## Rover Service News Letter No. 42

TO ALL DISTRIBUTORS AND DEALERS

Adjusting lock stop bolt.

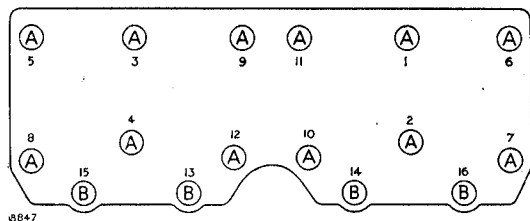
To improve the turning circle, from 50 ft. (15,25m) to 48-49 ft. (14,64-14,94m) on the Land-Rover 107 the solid block stop bolt has been replaced by an adjustable type bolt, Part No. 250698 with two locknuts, Part No. 2823, for each bolt.

This alteration has been incorporated from Vehicles numbered 47200002, 47230222 and 47260236 onwards. Any earlier vehicle can be modified by discarding the solid stop bolts and fitting two adjustable lock stop bolts and four locknuts. These should be adjusted to the dimension shown in the sketch. (86 dimension given for reference.)

- A. Lock stop bolt.
- B. Locknuts.
- C. Land-Rover 86, fitted with  
6.00 x 16 tyres. ....  $\frac{11}{16}$  in. (17,5 mm).  
Land-Rover 107, all models,  
and 86, fitted with 6.50 x 16  
or 7.00 x 16 tyres ....  $\frac{3}{4}$  in. (21,8 mm).

Order of tightening cylinder head bolts. "60".

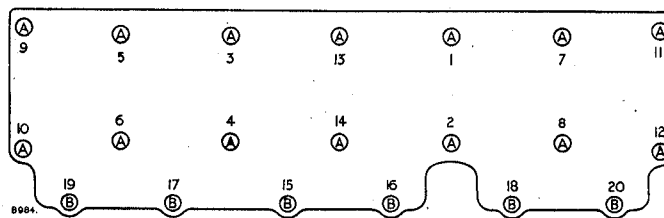
- Item 32 CYLINDER HEAD GASKETS 1954 "60" and "90"** Copper and asbestos cylinder head gaskets have been introduced on the "60" and "90" from Engines numbered 60: 43301316 onwards and 90: 45302015 onwards.

When refitting the cylinder head it is **very important** to tighten the cylinder head bolts in accordance with the diagrams below.

Bolts "A". Tighten to 50 lbs. ft. (7 mKg.) torque.

Bolts "B". Tighten to 30 lbs. ft. (4 mKg.) torque.
